Name: Blichmann Office Building – Site Plan Review – 2501 Blichmann

REVIEW COMMENTS

TITLE HEADING: Site Plan Review - Associated
Insurance Office Building

LOCATION: 2501 Blichmann (Foresight Park)

SITE PLAN

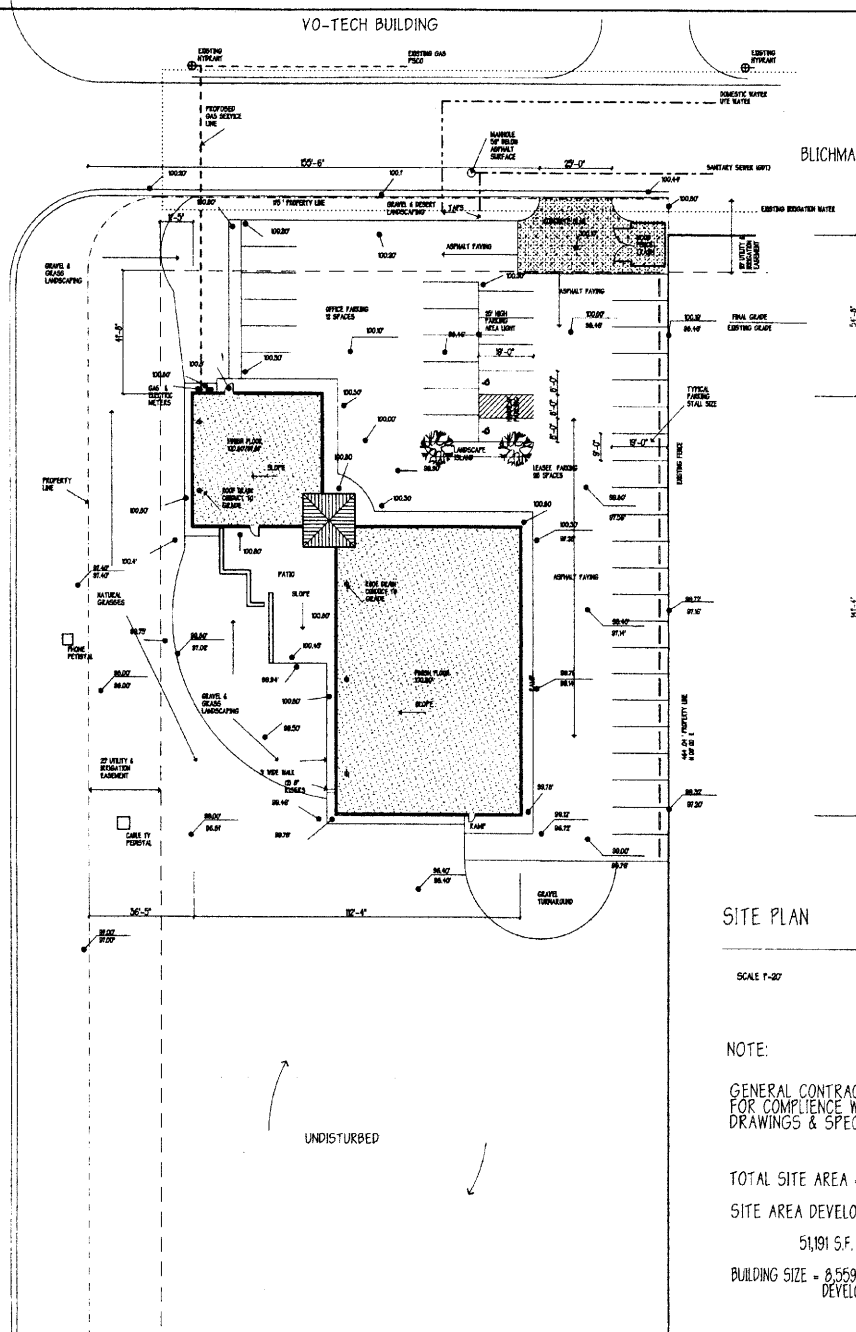
3. The driveway does not line up with the UTEC driveway across Blichmann. This should be lined up so conflicting left turn movements are avoided. Also, for an industrial street the minimum distance back from the intersection for a driveway is 100 feet (standard drawing attached). The use is more commercial than industrial, therefore the minimum driveway width should be 25 feet.
4. The site layout does not lend itself to on-site circulation to the undeveloped portion of the lot. For the future development on the lot, only one access point to 25 Road will be allowed.
5. A minimum of two (2) handicap spaces is required, and they must conform to the City Standard Detail (attached). This includes appropriate signs and markings.

1. SITE DESIGN - relocate access to provide greater distance from 25 Road/Blichmann intersection. This would also facilitate the potential future access to the southern portion of the property. Access onto 25 Road from the southern portion of the site is discouraged.

2. PARKING
 - Parking blocks are required for all 90 degree stalls facing the eastern property line
 - Need some provision for vehicle turnaround at the end of row of stalls on the east side of building (e.g. leave one stall open--no parking or provide cul-de-sac)

PRELIMINARY LANDSCAPE PLAN

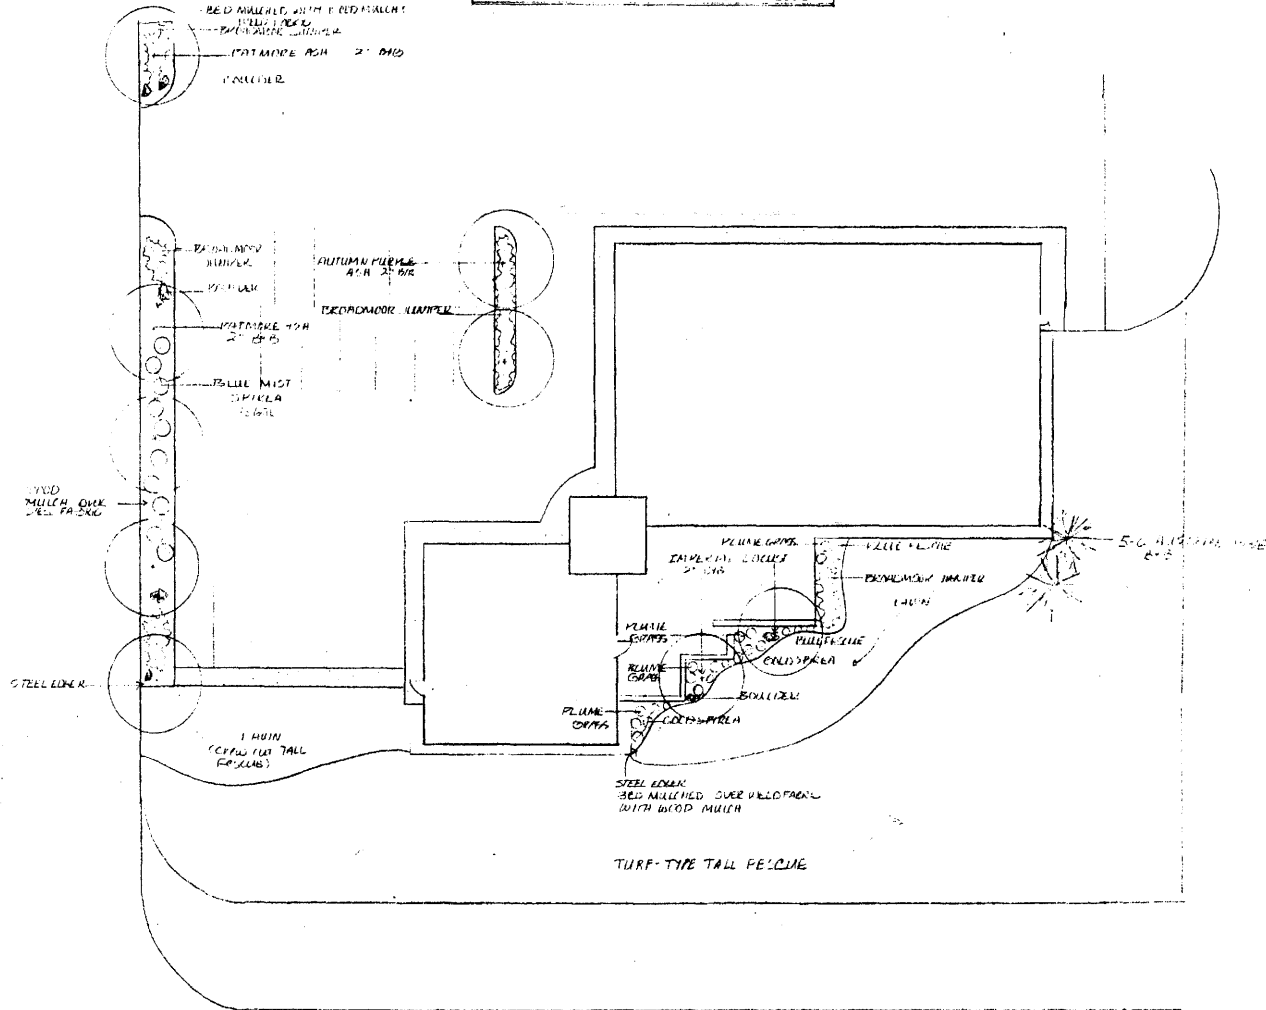
3. LANDSCAPE
 - A more detailed plan is required for review which identifies plant species, number, size and spacing and meets City Code (see attached).

- A letter of approval from the Architectural Control Committee is required regarding landscaping.
 - Underground, pressurized irrigation is required for all landscaped areas. Place a note on the plan that this will be provided.
